**CAPITOL ZONING DISTRICT COMMISSION  
STAFF REPORT  
8/24/16  
BIM/ TDM**

**Location:** 204 – 206 South Bishop Street and 1706 – 1724 West Third Street  
**Applicant:** John Johnson for Mullenix Land Company  
**Permit Types:** Certificate of Appropriateness with Height Review and Conditional Use Permit

**Project Description:** This application is for a Certificate of Appropriateness to allow for the removal of the Precision Motors building (along with a small ancillary structure) at 204 South Bishop, and the construction of a new four-story mixed-use building and related site improvements. The proposed new building features a contemporary design with walls made of scored concrete stucco and cementitious fiberboard siding, a masonry foundation, and a flat roof. The application also proposes to use the property at 1706 West Third for parking and to develop the wooded parcel at 1724 West Third as a new parking lot. [Note- updated renderings based on feedback from staff and committees are on Pages 31-32 of this report.]

Renderings updated based on Design Review and Capitol Area Advisory Committee recommendations

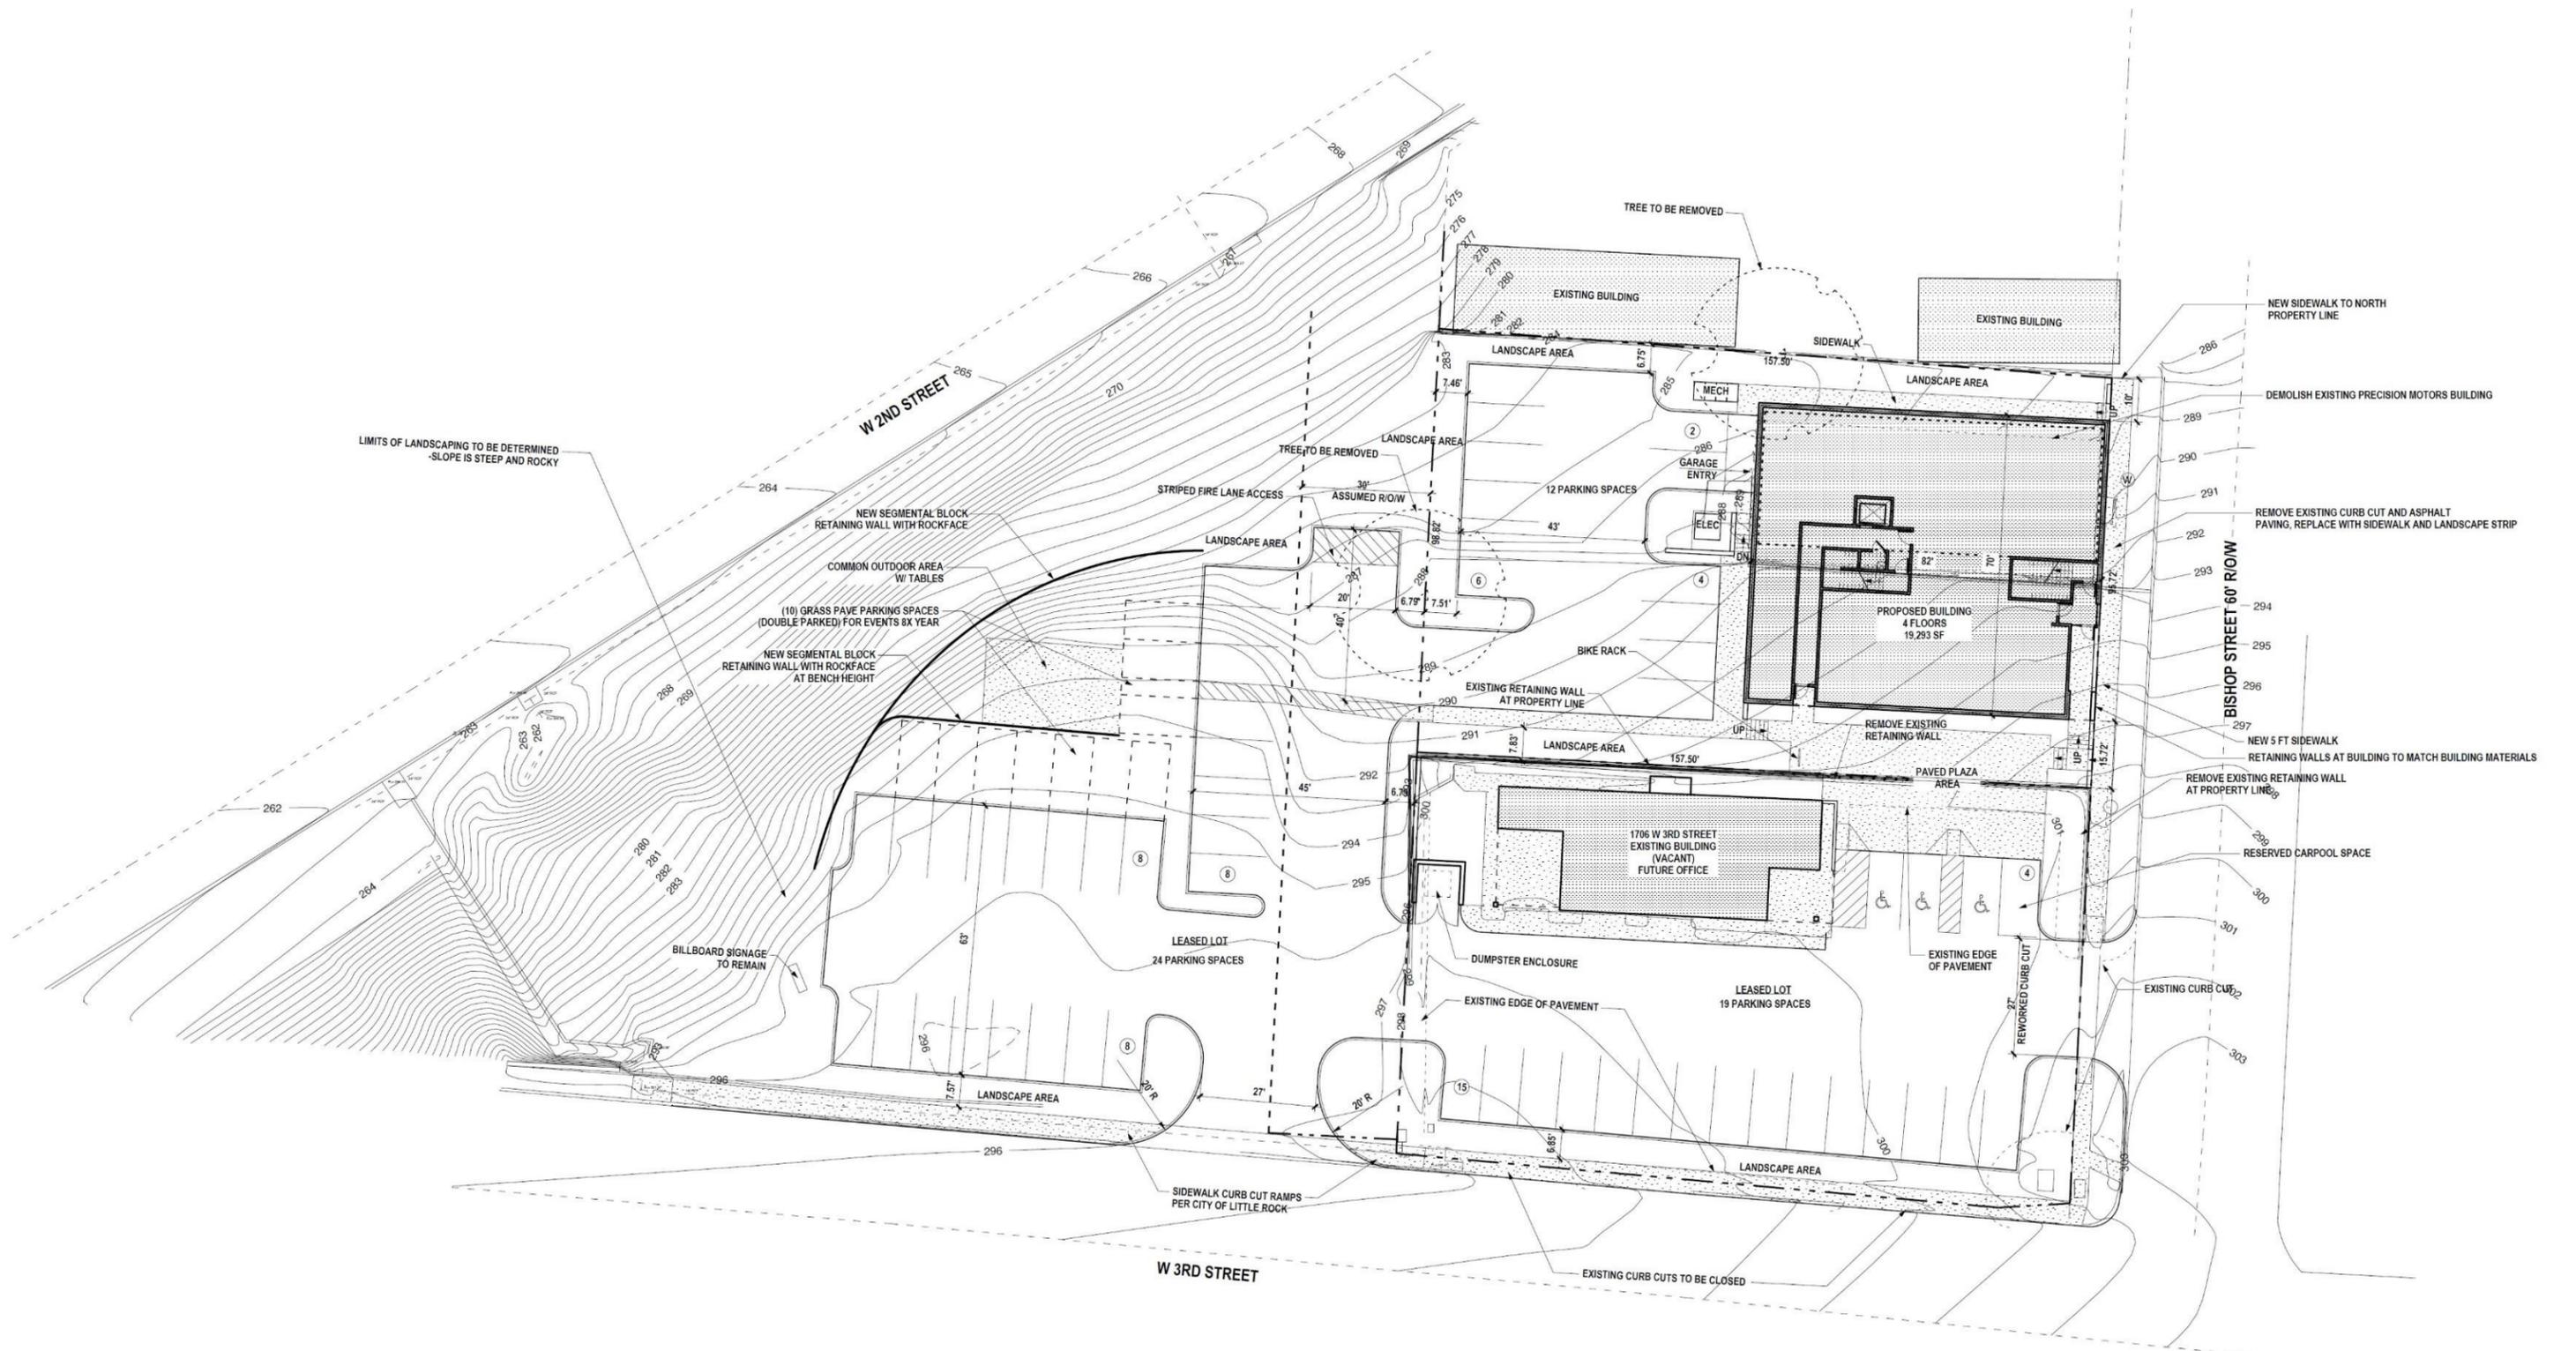
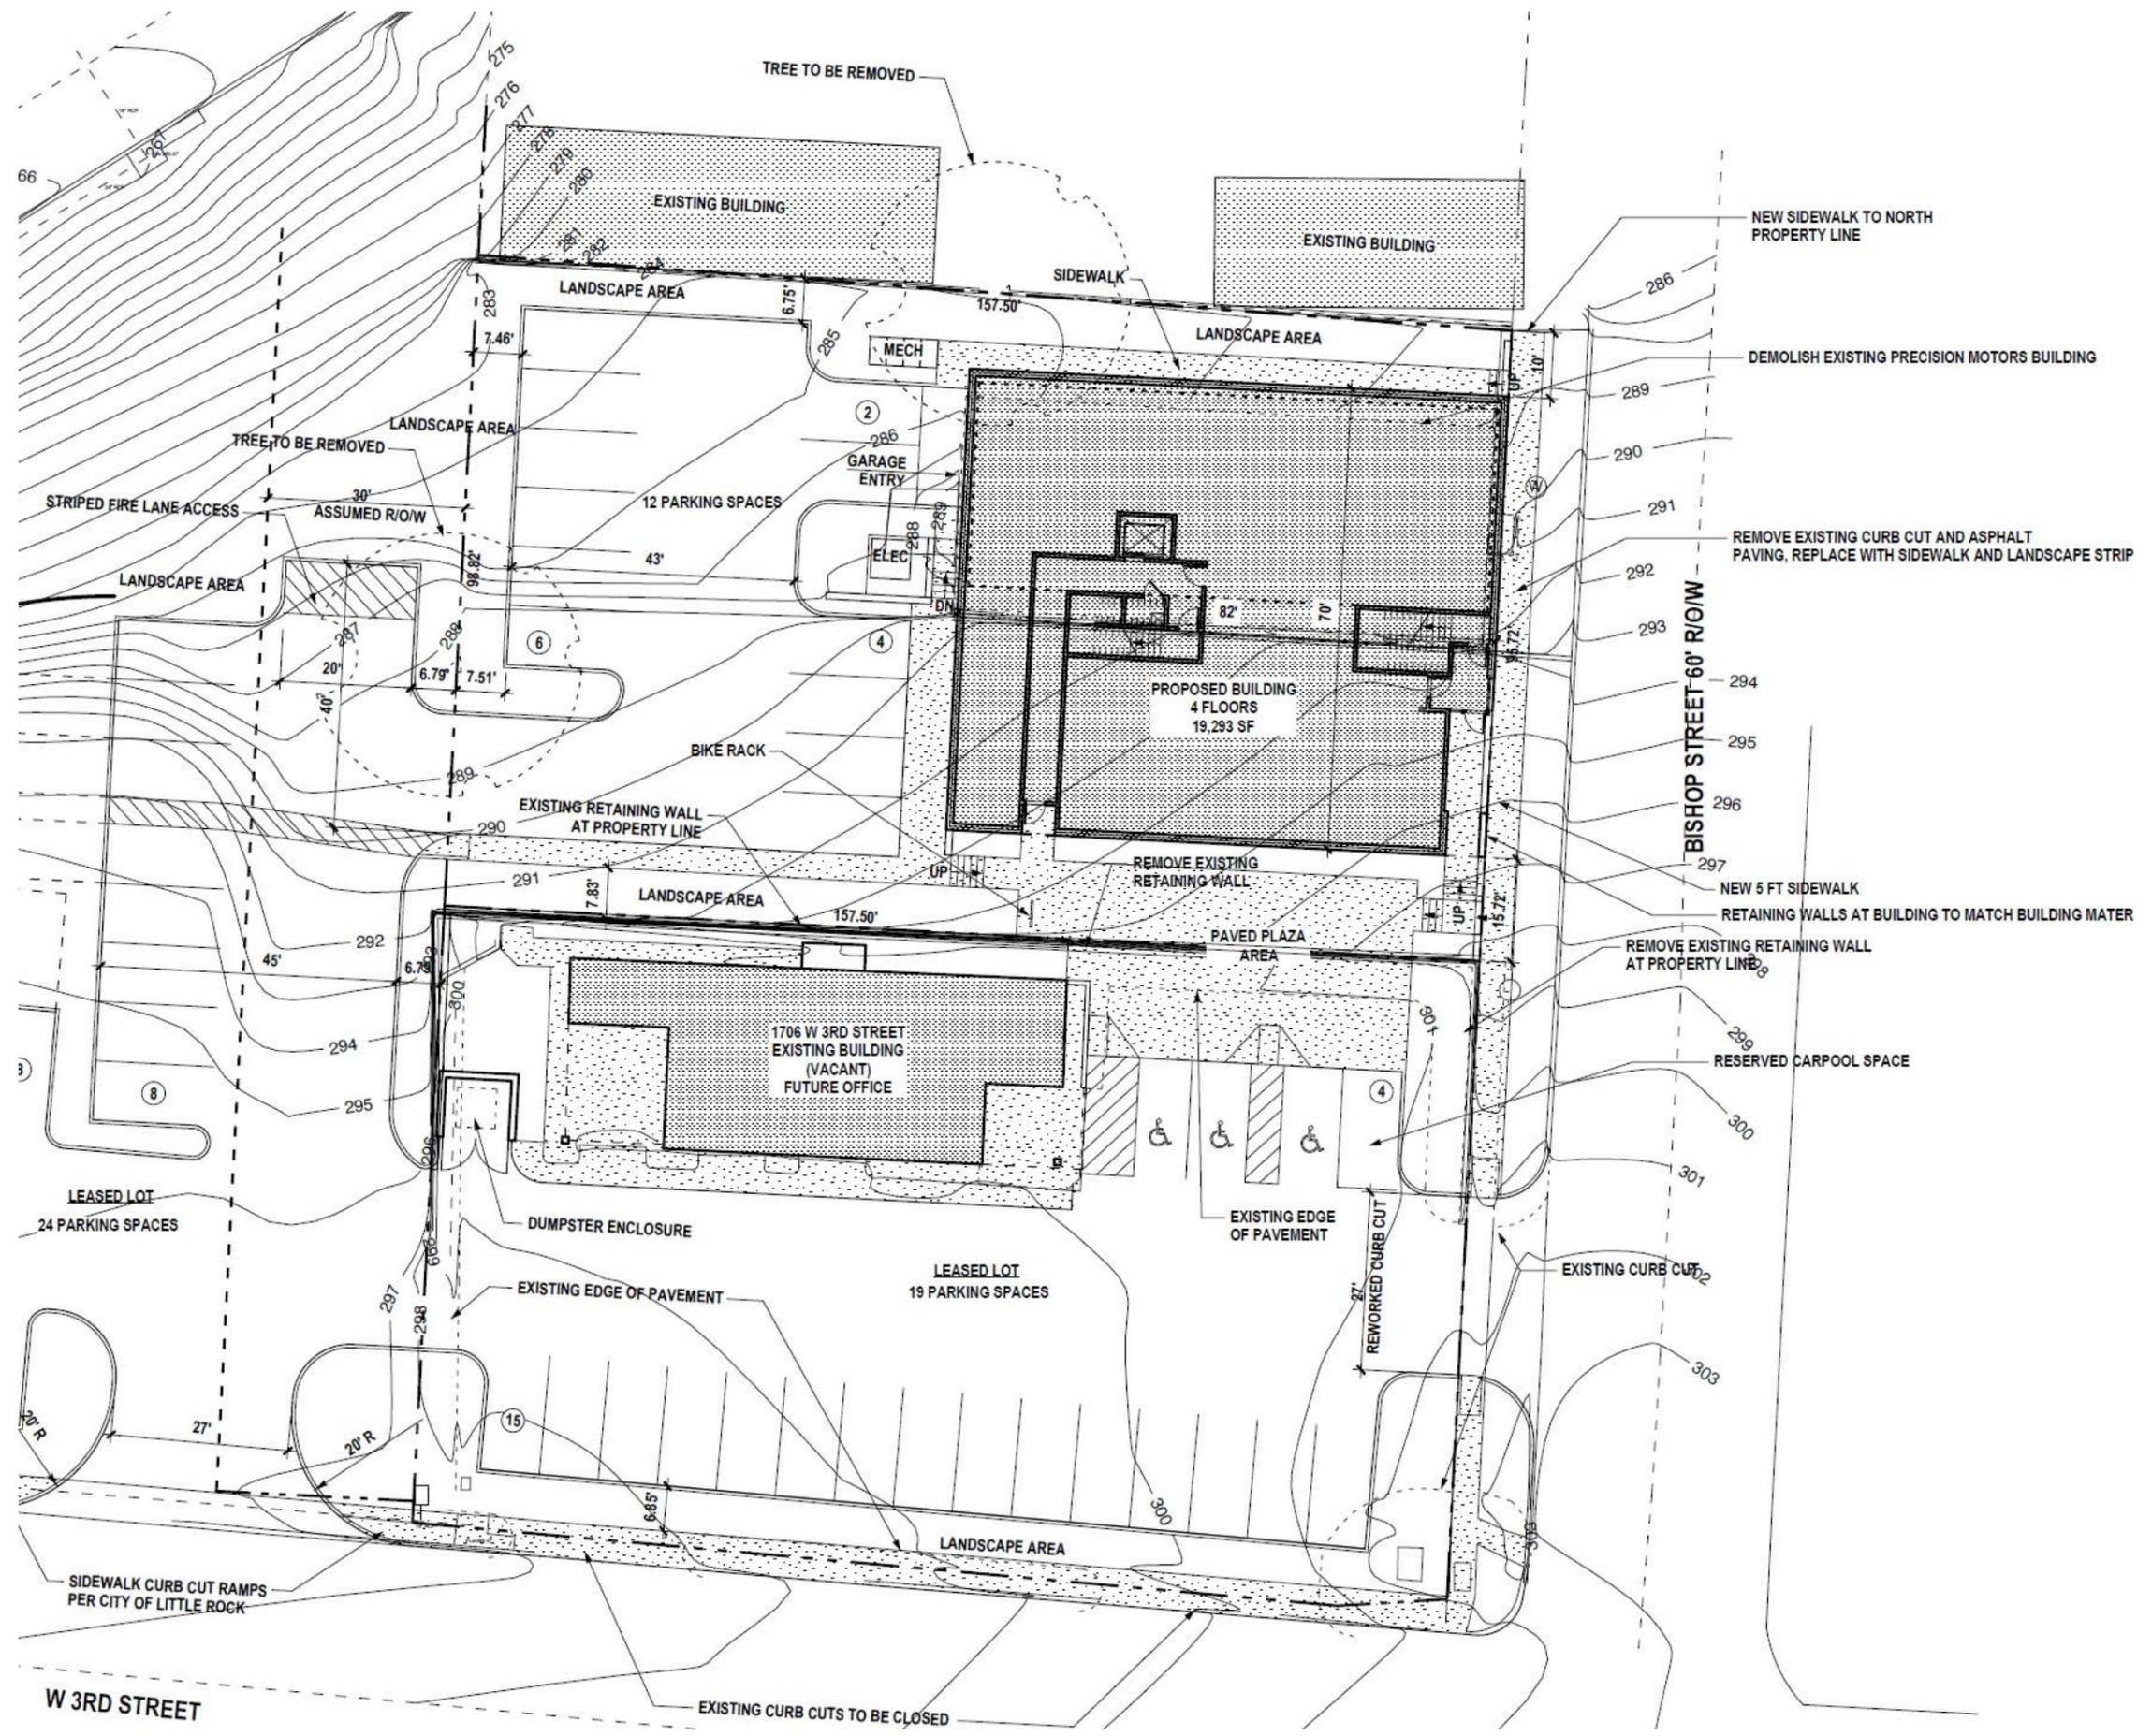
**Design Review Committee update:** The committee voted unanimously (4-0) to also recommend **approval** of the application with staff's recommendations. Members discussed the importance of incorporating scoring into the walls to break up large expanses of stucco, possible concerns about blocking views from the north, and the need for more detail on re-vegetating the portions of the sloped parcel cleared earlier this year.

**Capitol Area Advisory Committee update:** The committee voted unanimously to recommend **approval**. Some members agreed with staff and the DRC that the walls should be broken up into smaller blocks, and one member suggested also breaking up the large windows with some horizontal elements. The applicant stated that they were working on incorporating those suggestions into the design. **[Updated renderings are shown on Pages 31-32 of this report.]**

NEW SIDEWALK TO NORTH PROPERTY LINE  
DEMOLISH EXISTING PRECISION MOTORS BUILDING  
REMOVE EXISTING CURB CUT AND ASPHALT PAVING, REPLACE WITH SIDEWALK AND LANDSCAPE STRIP  
NEW 5 FT SIDEWALK RETAINING WALLS AT BUILDING TO MATCH BUILDING MATERIALS  
REMOVE EXISTING RETAINING WALL AT PROPERTY LINE  
RESERVED CARPOOL SPACE
